ADDENDUM #1

**Orangewood Vertical Curve Realignment Project
0.6 miles West of Hall Road, Tehama County, California**

**COUNTY PROJECT NUMBER: 237681
FEDERAL PROJECT NUMBER: HSIPL 5908(073)**

EXHIBIT 1B

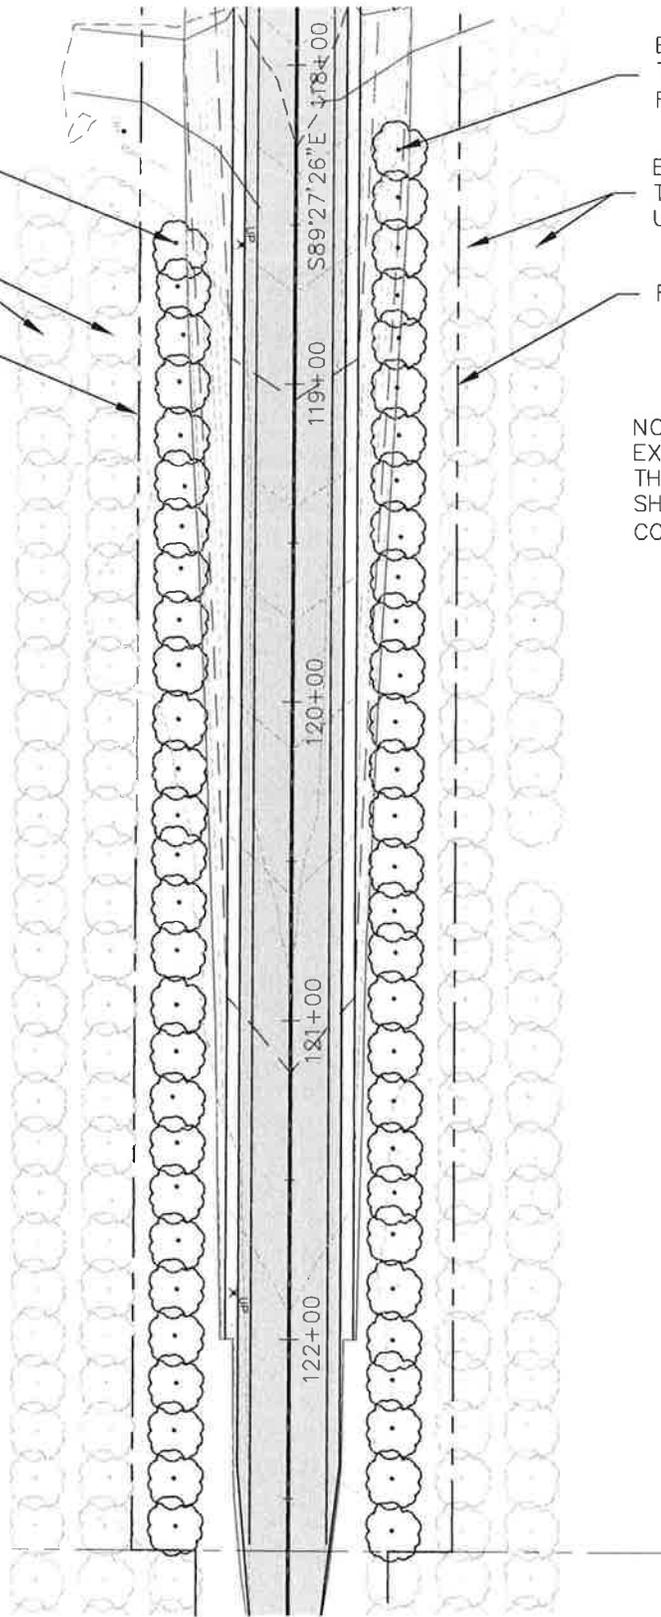
Refer to plan sheet P-2.

Attached Exhibit 1B clarifies existing orchard trees to be removed by contactor.

EXISTING ORCHARD TREES TO BE REMOVED (28)

EXISTING ORCHARD TREES TO BE REMOVED (30)

NOTE:
EXISTING ORCHARD TREES WITHIN THE RIGHT OF WAY AS SHOWN SHALL BE REMOVED BY CONTRACTOR (58 TOTAL)
